GOVERNMENT OF THE DISTRICT OF COLUMBIA
OFFICE OF PLANNING

**MEMORANDUM**

**SUBJECT:** Request for Processing Zoning Commission Case No. 01-28TE/93-3C (Extension of Z.C. Order Nos. 783-A in Case No. 93-3C. (PUD 200 K Street, N.E)

LOT OCCUPANCY

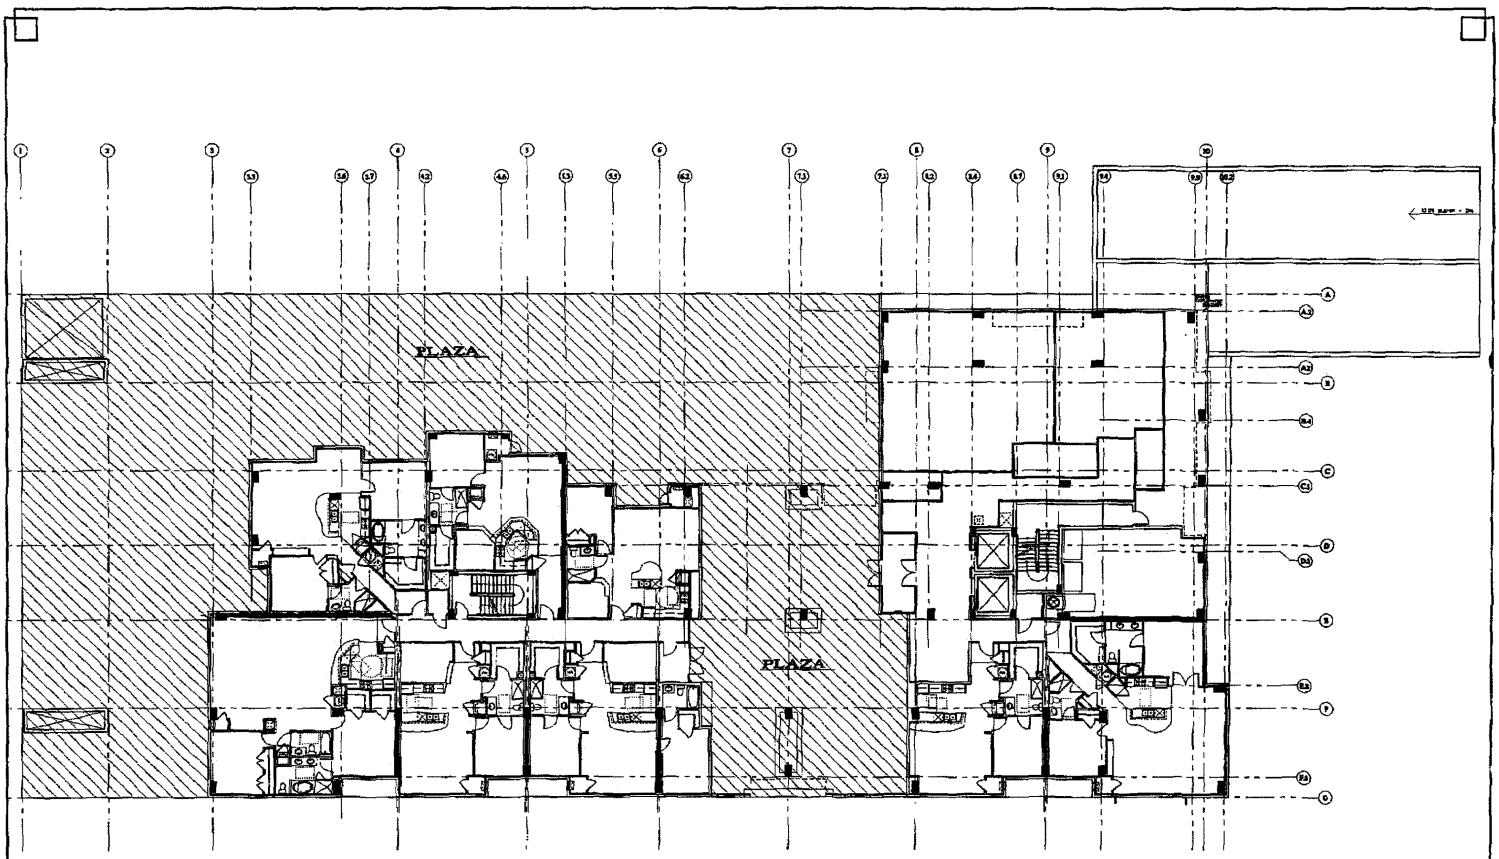
- Massing – In the design approved by the PUD, the housing was tiered with set backs at 36.5 feet, 87.5 feet and topped out at 130'. The extension submission is 12 stories the entire length of the building, resulting in a 130 foot height across the entire 3rd street frontage.

BUILDING HEIGHT

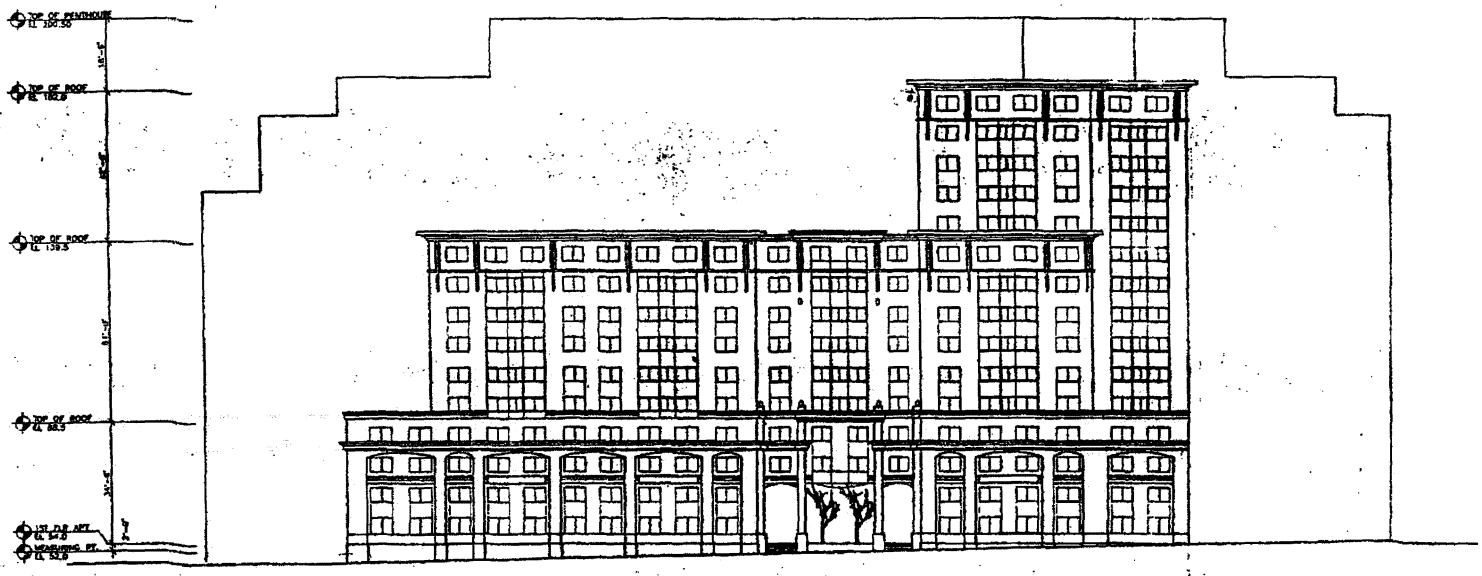
1) The changes in height and massing of the building, particularly in light of the Department of Housing and Community Development's statement of concern regarding the height in the PUD order;
2) The potential precedent this would establish for other PUD extensions. It should be noted that the overall density has not changed and the reduction of units/households would reduce any possible traffic congestion or other density related impacts.
